TRIMMED: Submission on DA2025/0008 62-64 Powderworks Road and 32 Subject:

Bellara Avenue North Narrabeen

Submission on DA 2024/0008 62 and 64 Powderworks Road and 32 Bellara Avenue North Narrabeen 10 February 2025

Ridgeline view impacts

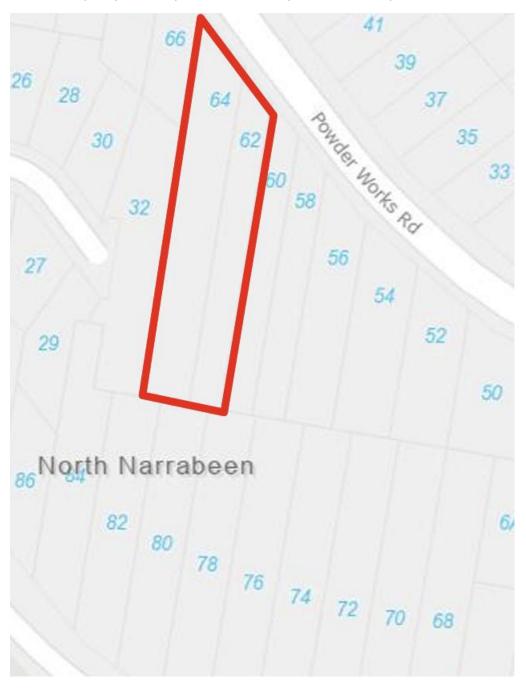
If approved the DA would result in the loss of significant, substantial native trees on the steepest and most heavily vegetated part of the site. The resultant "scar" would be highly visible and disrupt views to the existing, heavily vegetated ridgeline from parts of North Narrabeen and Elanora Heights, as well as the public domain of Nareen Park.

This would also be a cumulative view impact from the existing, substantial driveway entrance and associated works at no.32 Bellara Avenue that has resulted in significant tree loss and erosion. See Photos 1 and 2 earlier.

The proposed development does not meet the intent and requirements of DCP C1.2, overall D.11 (particularly 11.2) and D11.15.
